# BULLETIN

## SAFETY RECALL

### 2009 ~ 2014 YZF-R1 ("R1") AND 2012 ~ 2013 XTZ1200 ("Super Ténéré") FACTORY MODIFICATION CAMPAIGN - Headlight Terminal Overheating (NHTSA 14V044)

HEAT DAMAGE TO THE HEADLIGHT TERMINAL COUPLER AS A RESULT OF THERMAL EXPANSION OF THE TERMINAL CONNECTOR

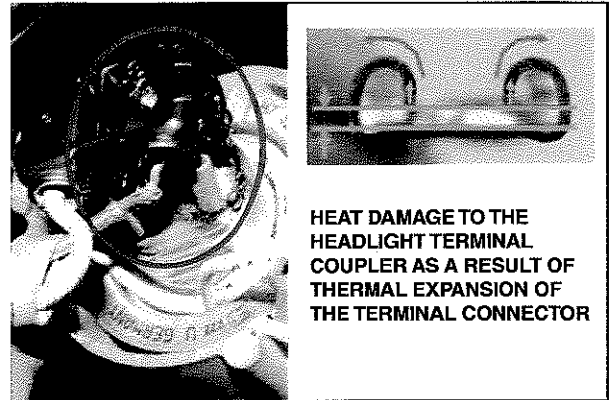
Yamaha Motor Corporation, U.S.A. has decided that a defect which relates to motor vehicle safety exists in 2009~2014 YZF-R1 and 2012~2013 XTZ1200 ("Super Ténéré") model motorcycles. In affected motorcycles, due to improper heat resistance of the headlight bulb terminal connector, thermal expansion of the terminal connector can cause arcing between the terminal connector and the headlight bulb contact, resulting in coupler melting. If this happens, the headlight might malfunction which could result in the possibility of a crash with injury or death.

To correct this problem, Yamaha is initiating a Factory Modification Campaign. Affected units must have the headlight bulb sub-lead replaced.

### YZ-R1

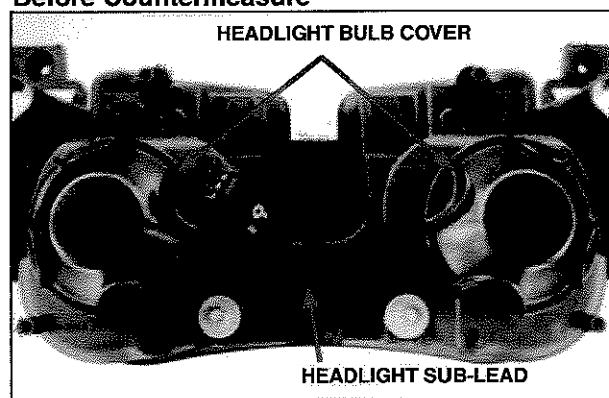
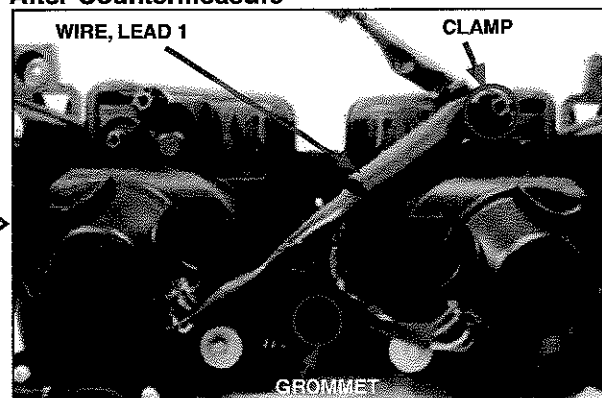
#### Before Countermeasure

#### After Countermeasure

As shown above, the wire routing of the new headlight sub-lead (Wire, Lead 1) is different than the original wire routing.

Removal of the original sub lead requires cutting the connectors from the lead and pulling them through the headlight housing.

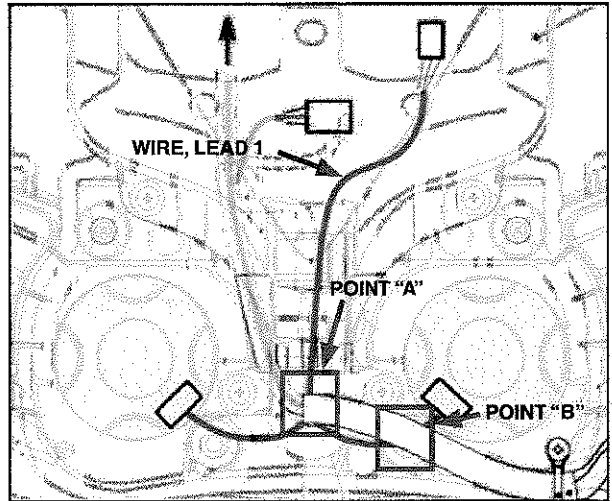
5. Check the routing of the sub-lead (Wire, Lead 1) at point "A" and "B" as shown in the adjacent illustration.
